Rev	Date	Purpose	Document Ref	Comments
-	November 2022	Issued for Planning	295AB_1MS&WCS_MS	Design Amendments

One Museum Street

One Museum Street: Design Amendments

Selkirk House, 166 High Holborn and 1 Museum Street, 10-12 Museum Street, 35-41 New Oxford Street and 16A-18 West Central Street, London, WC1A 1JR

View of Museum Street colonnade (Submitted Scheme)

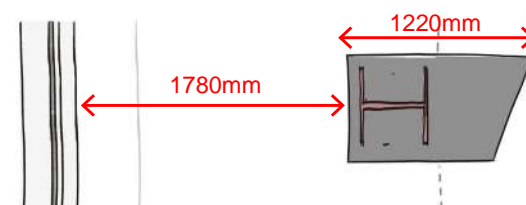
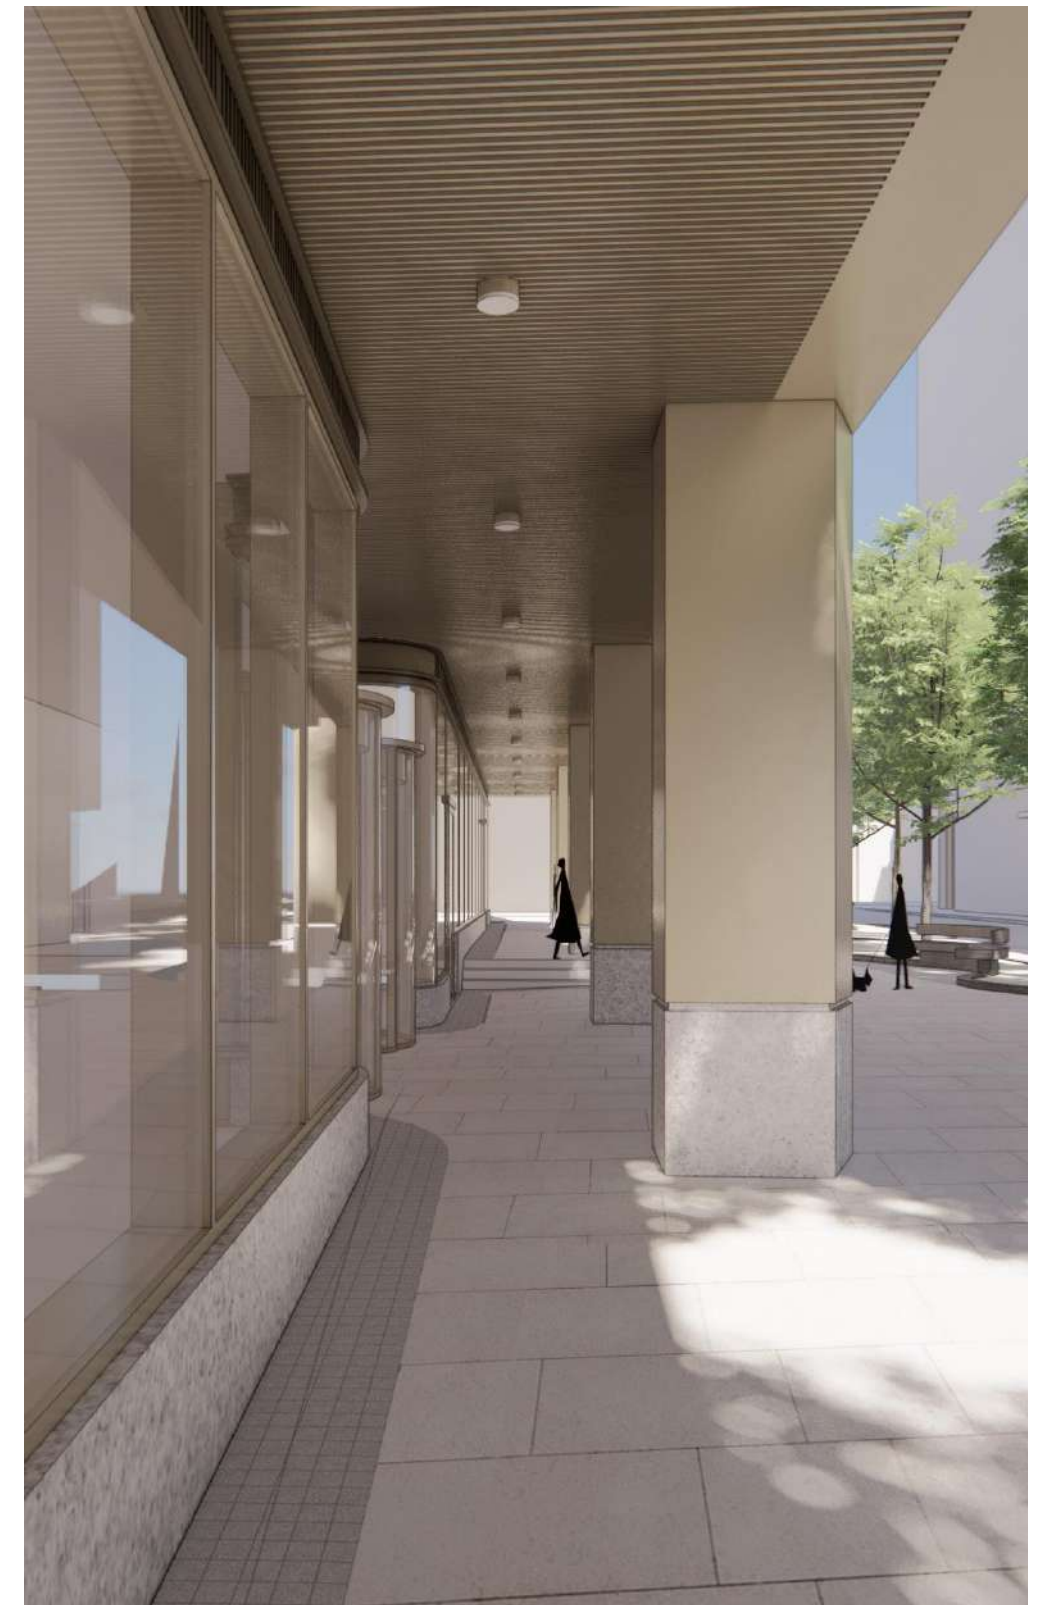
The submitted scheme proposed a colonnade which was 1780mm deep (between the back of the columns and the facade) with columns which were 1220mm deep. This proposal sought to continue the line of the facade down to ground whilst encasing the steel structure within.

Whilst this option created a strong relationship between the colonnade and the remainder of the building above, Camden have raised concerns regarding the depth of the colonnade and the pedestrian experience when using the space.

Proposed view of Museum Street colonnade

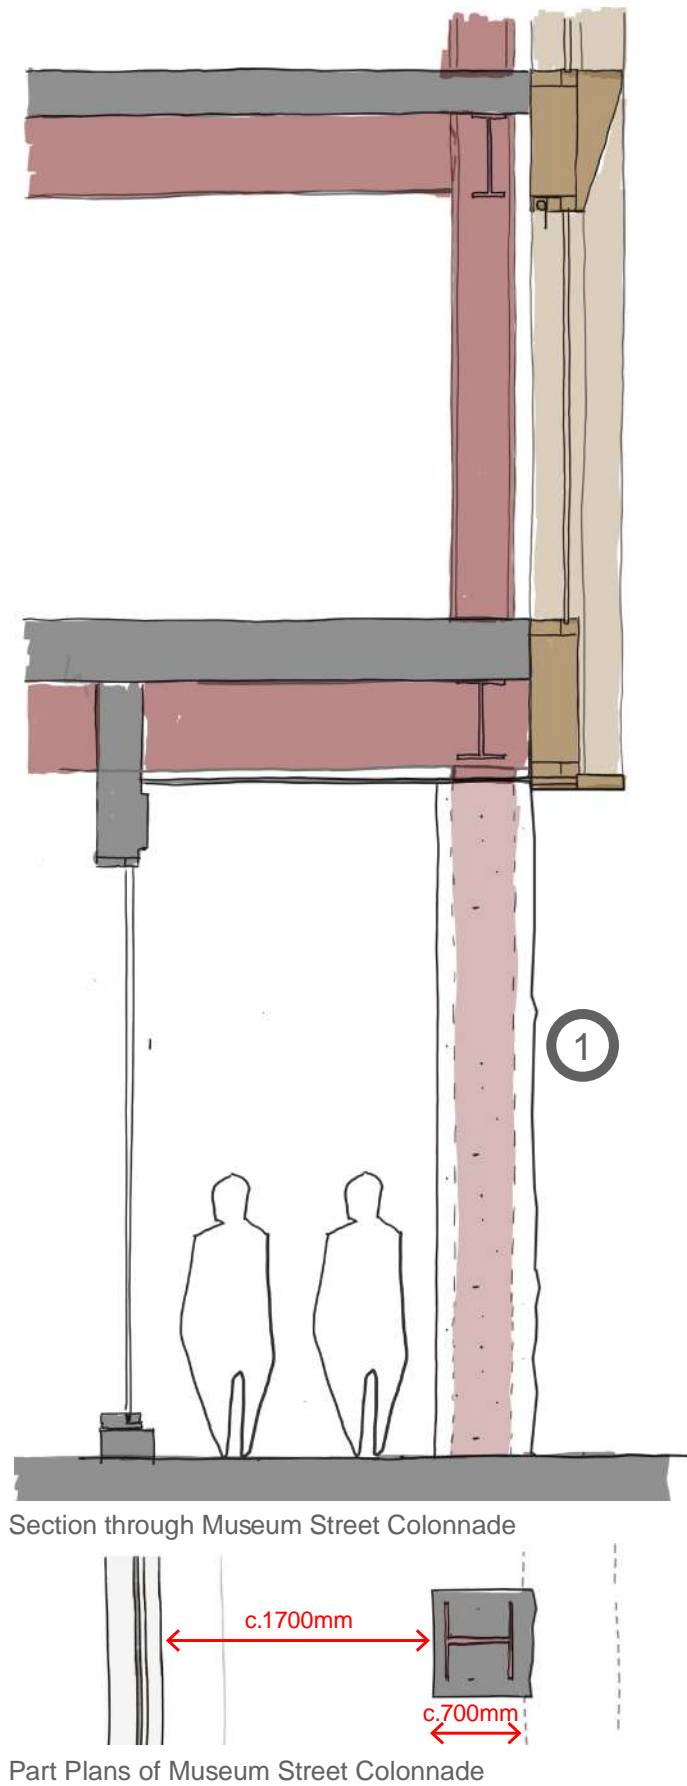
To address the aforementioned concerns, different options have been tested and the revised proposals include:

- 1. Stone columns meeting the ground which are designed to a reduced depth of c.700mm

Interest is added to the simple stone columns, with just one outward-facing “hewn” face that speaks of the load above and earlier histories of the site. Each column is unique and changes with the site’s gently sloping ground, without a base plinth as before.

Preliminary advice suggests that structural stone could be used in this scenario, which would be the preference. This is however subject to further structural analysis. Alternatively, steel columns could be clad in stone to achieve the same effect.

- 2. The colonnade paving is broken into bays to. Finely ribbed granite is proposed to match the soffit.

- 3. Finely ribbed panels (stone, GRC or similar) are proposed to clad the soffit. Mirroring the ground floor rhythm and texture further helps to connect this space with the wider public realm.

Proposed Reflected Ceiling Plan of 1MS Colonnade

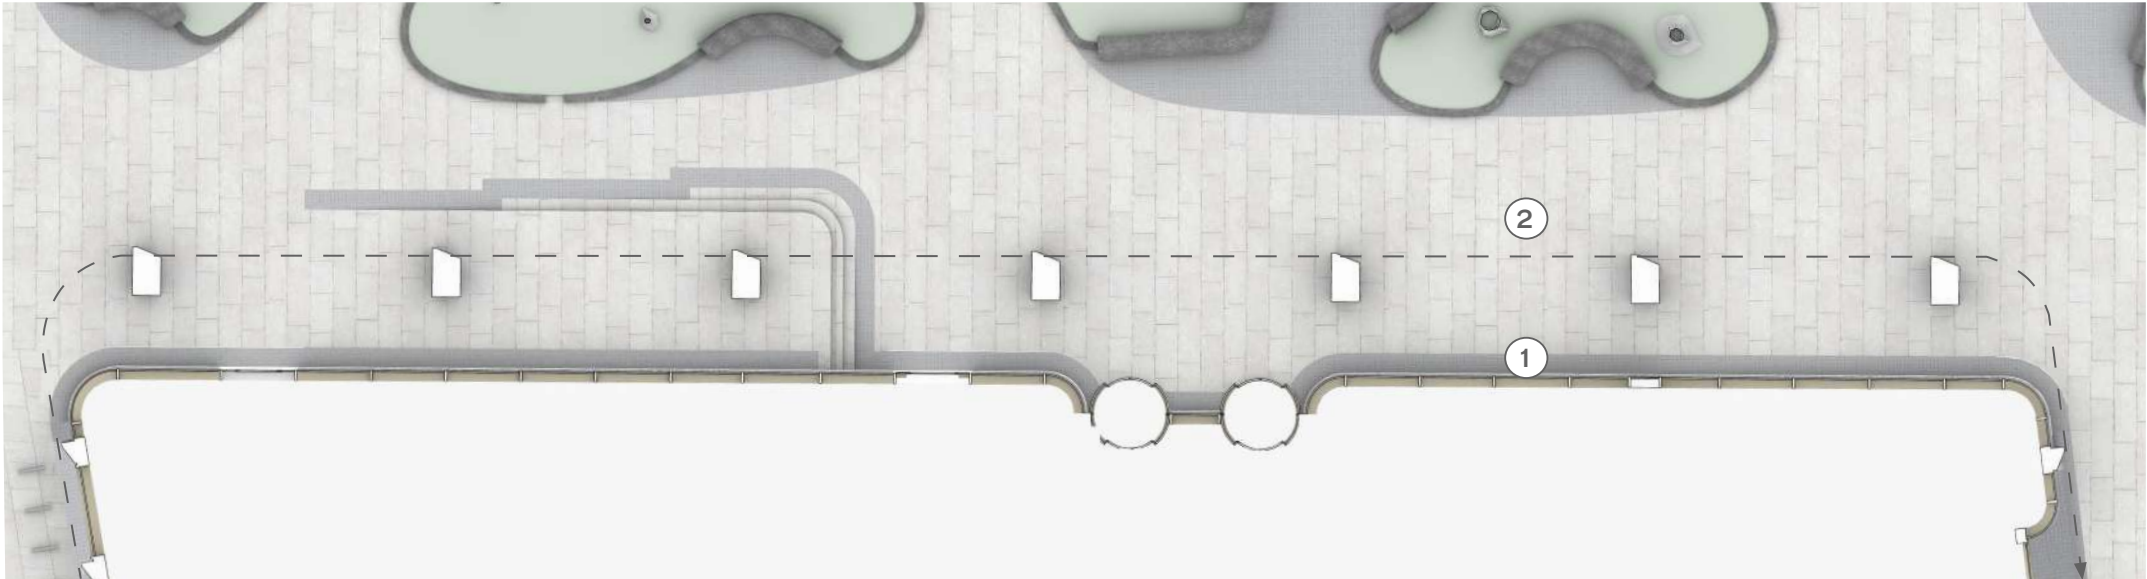
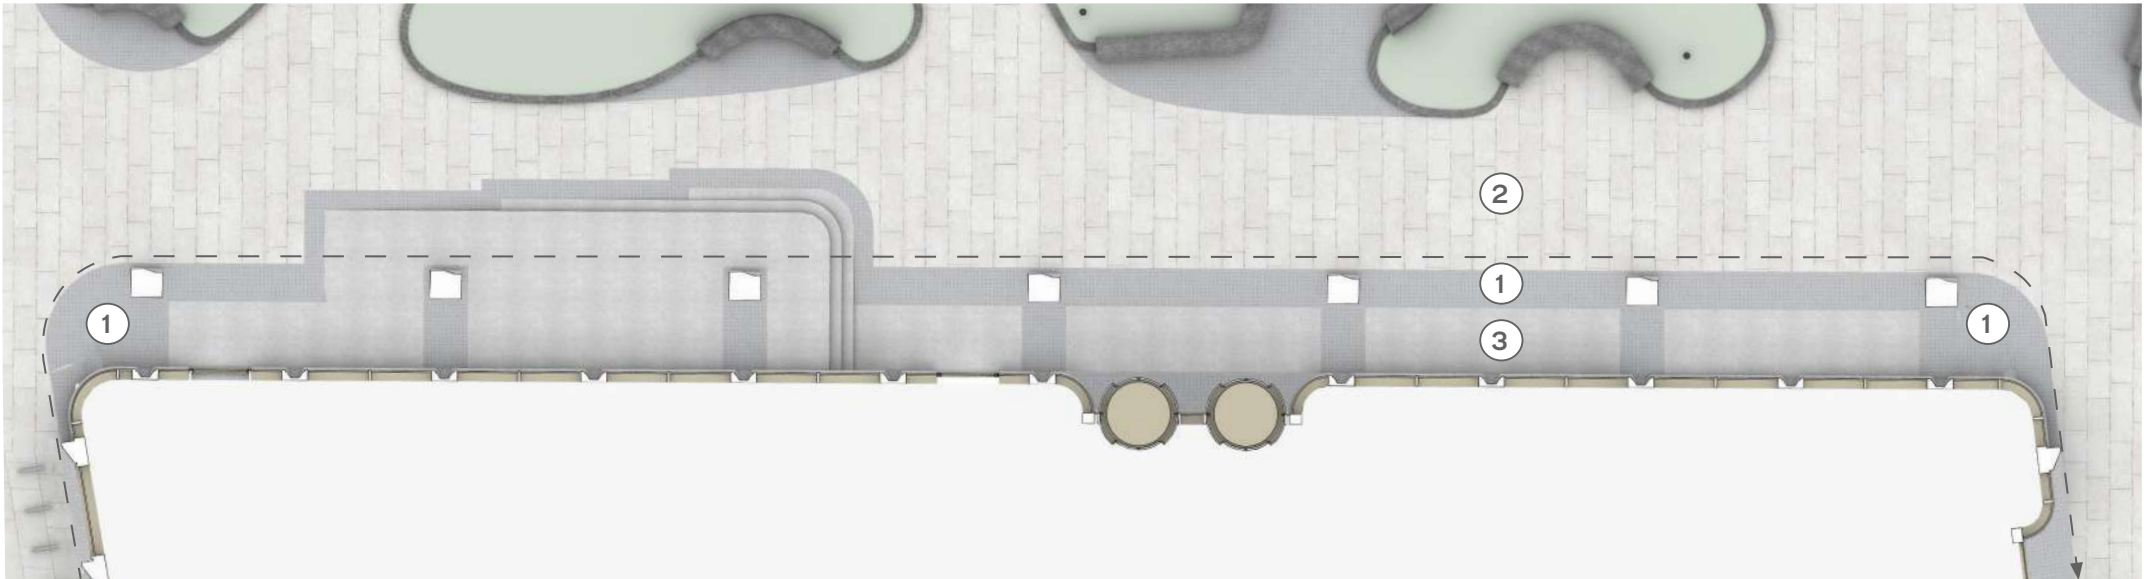
The submitted scheme colonnade so it proposed the use of Profiled Light Bronze Aluminium however Camden have since raised concerns regarding its harsh appearance.

The revised design proposes the use of finely ribbed panels (stone, GRC or similar) to articulate the colonnade so it with finely ribbed granite paving. The ribbed panels are then broken down into bays to give a better sense of scale along the colonnade elevation. Overall, this creates a stronger link with the public realm design.

Bay Study of Museum Street Colonnade

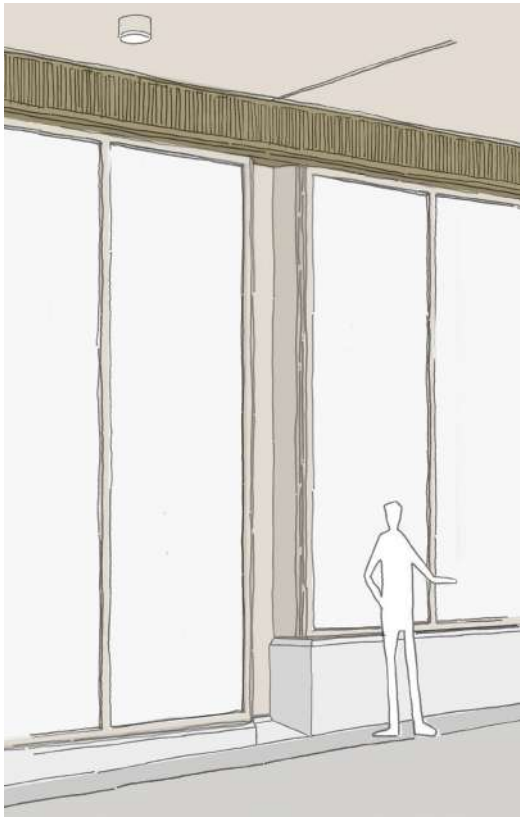
The submitted scheme proposed a consistent elevation along the length of the colonnade using 1.875m wide glass panels.

The revised scheme introduces additional framing to the glazing. Depth and interest is also added to this facade by recessing vertical elements to create protruding bays. This has been introduced in order to relate more to the human scale and add interest along the extent of this facade.

Museum St Entrance : Elevation

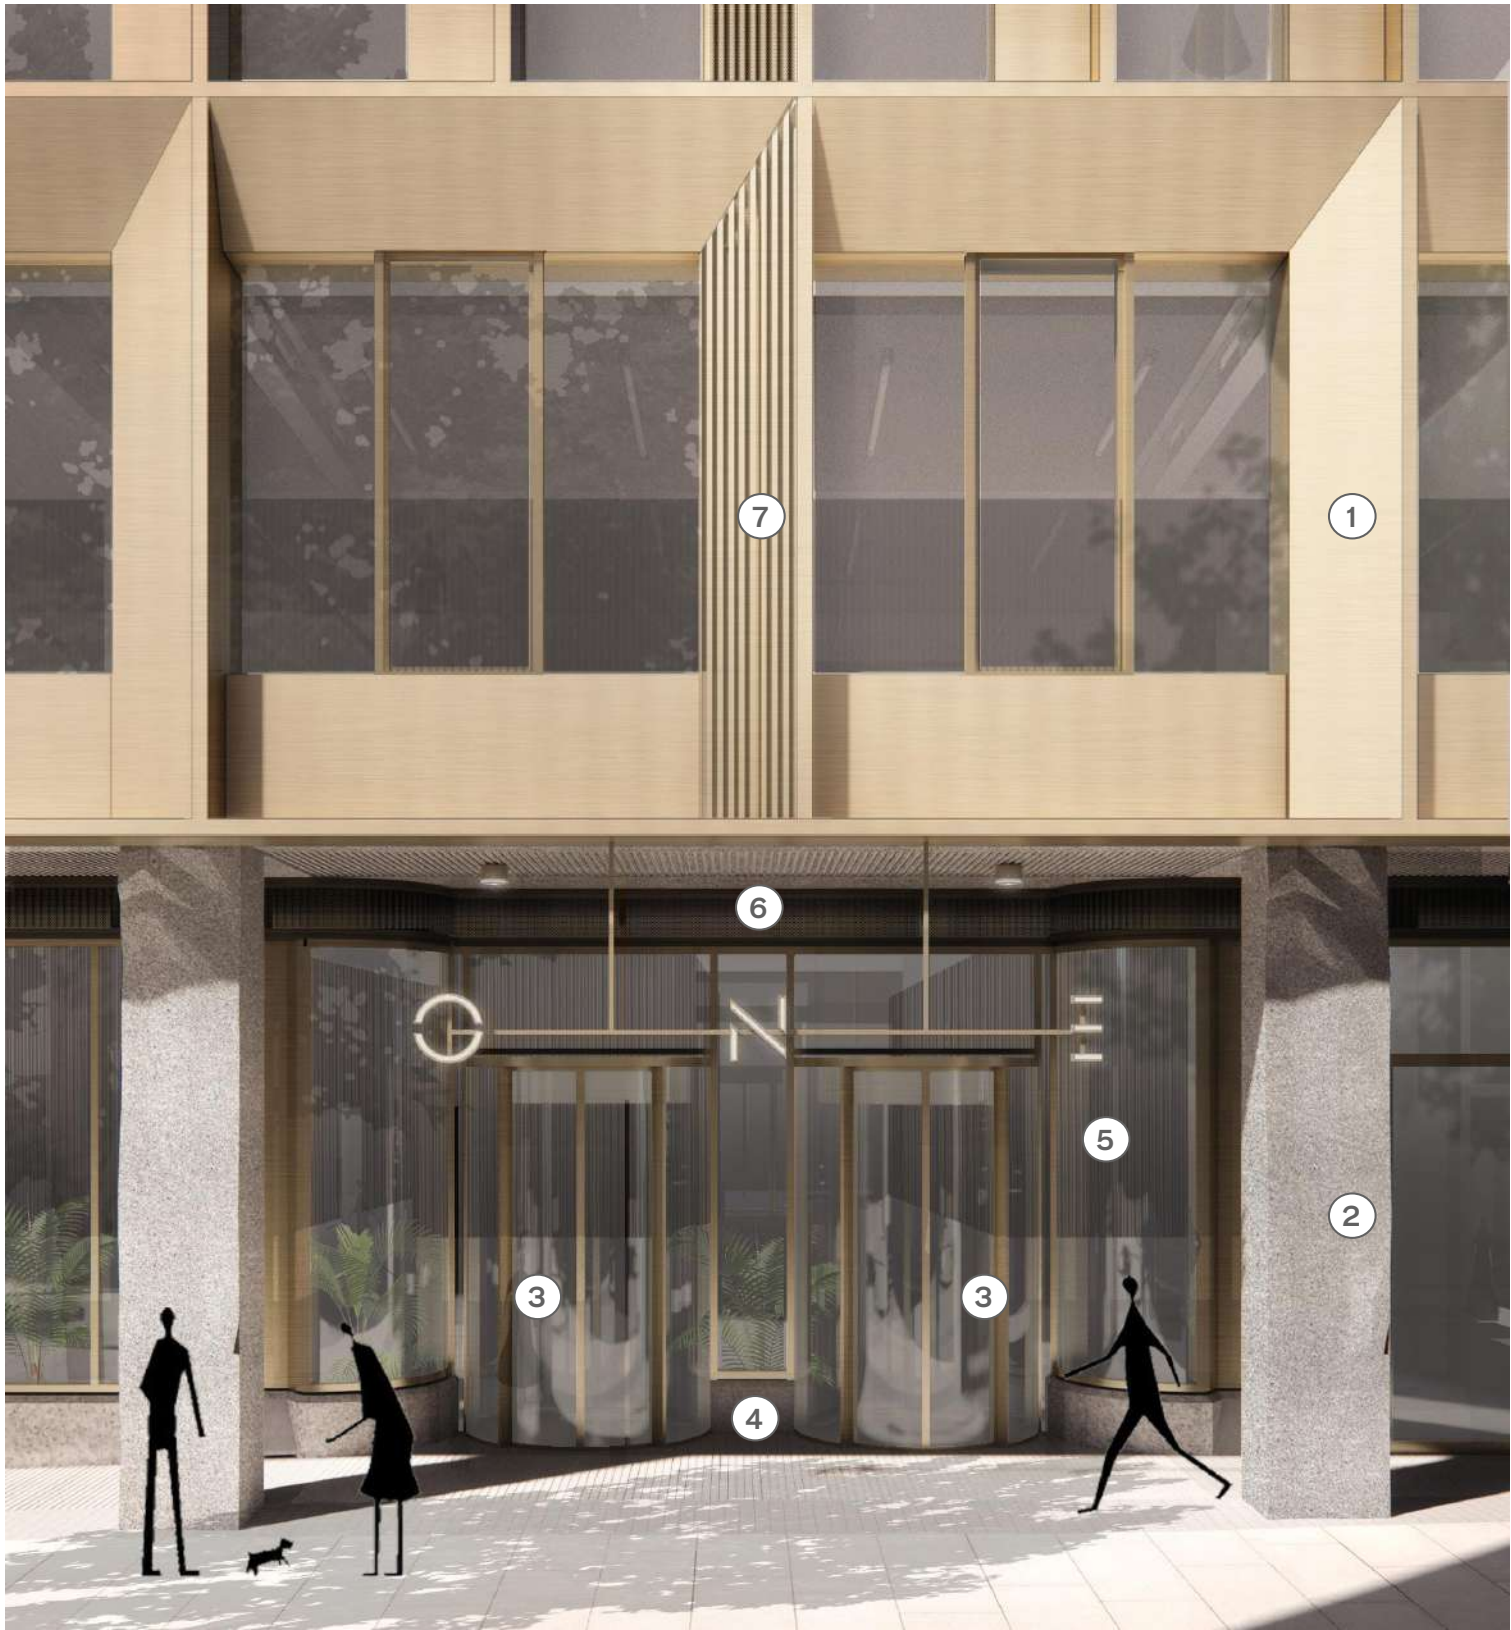
The main entrance to the One Museum St office use is composed of two automated circular sliding doors within an open, glazed curtain walling system. Their location, sitting centrally between the colonnade columns, allows for maximum external visibility but also allows straight views through the open lift lobby to Vine Lane on the west.

At the base, a continuous silver granite upstand establishes a relationship in materiality between the building and the adjoining landscape in addition to creating a suitably durable and robust footing.

The proposed design amendments seek to create a stronger relationship between the ground floor facade treatment and the public realm. The use of granite seeks to bring the public realm into the building line whilst clearly demarking a transitional zone.

Proposed Bay Study of One Museum Street First Floor Facade

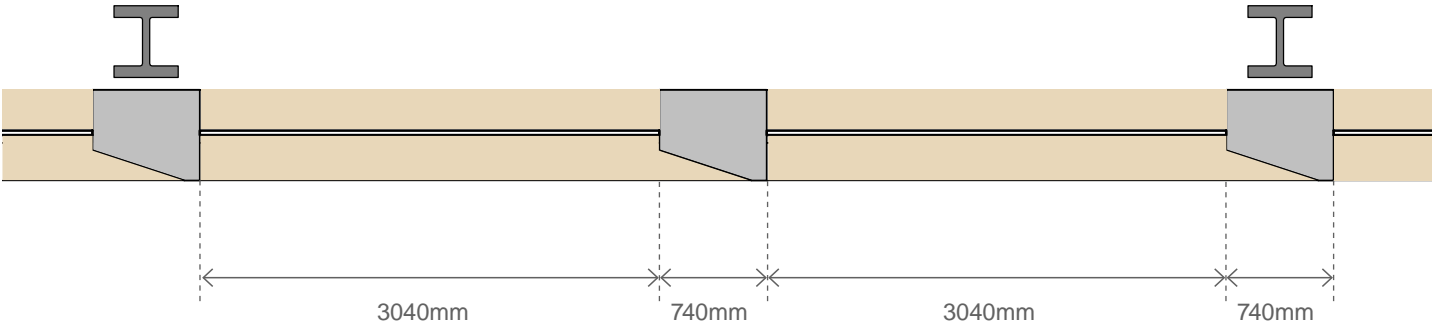
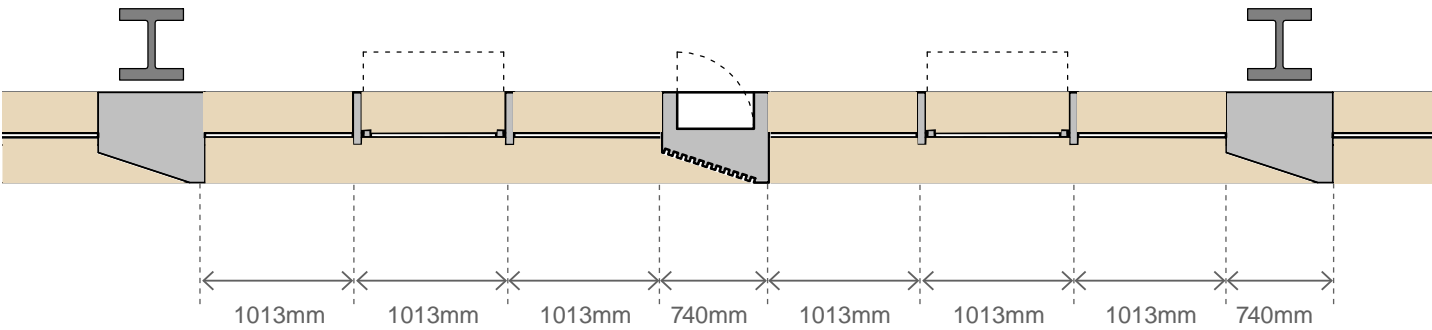
The submitted scheme proposed generous glazed panels at first floor level which were 3040mm wide. This bay size created a 2-storey base and a piano noble composition which was felt to be appropriate for a building of this scale in this context. However, concerns were raised with the scale of the panels and the fact that these were fixed. These points been formed the basis of the proposed design amendments.

The revised design breaks down the scale of the first floor glazing by introducing vertical mullions at c.1m centres.

Centrally within each bay, a top-hung window allows natural ventilation.

Additionally, an openable vent can be incorporated within the solid facade panel as per the floors above. This would be clad in corrugated perforated metal to match L02-L04

Fritting is proposed to the lower portion of the glazing to obscure vision from the public realm, creating a cleaner appearance of the building at this level and providing internal privacy.
